Advice from: Dr Lyn Denison

Date of response: 12 September 2017

West Gate Tunnel Project IAC

Fig. 3
Effects
of road traffic
noise at night*

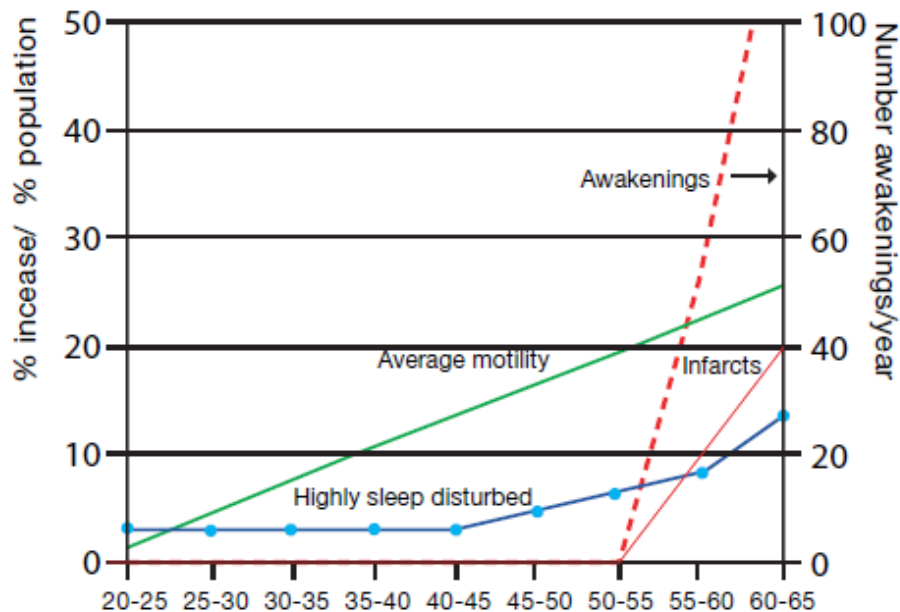
The number of awakenings is shown by the red broken line. The WHO (2009) state that for a Lnight outside of 60-65dB the maximum number of additional awakenings per year is 300. The WHO Europe Night Noise Guidelines (WHO, 2009) were based on expert-consensus that there was sufficient evidence that nocturnal environmental noise exposure was related to self-reported sleep disturbance and medication use, and that there was some evidence for effects of nocturnal noise exposure on high blood pressure (hypertension) and heart attacks. The WHO Europe Night Noise Guidelines state that the target for nocturnal noise exposure should be 40 dB Lnight, outside, which should protect the public as well as vulnerable groups such as the elderly, children, and the chronically ill from the effects of nocturnal noise exposure on health. The Night Noise Guidelines also recommend the level of 55 dB Lnight, outside, as an interim target for countries wishing to adopt a step-wise approach to the guidelines. It is worth noting that the 40dB Lnight outside guideline represents a very low level of noise exposure, e.g. a refrigerator humming.

The dose response relationships derived by WHO for night time noise should be considered in the adoption of noise guidelines applicable for the project. The relationships show a steep increase in awakenings above an L_{night} of 50 – 55Db.

For the most impacted receptors where increases in noise are predicted that are related to the project additional mitigation measures should be considered to minimise the risk to health.
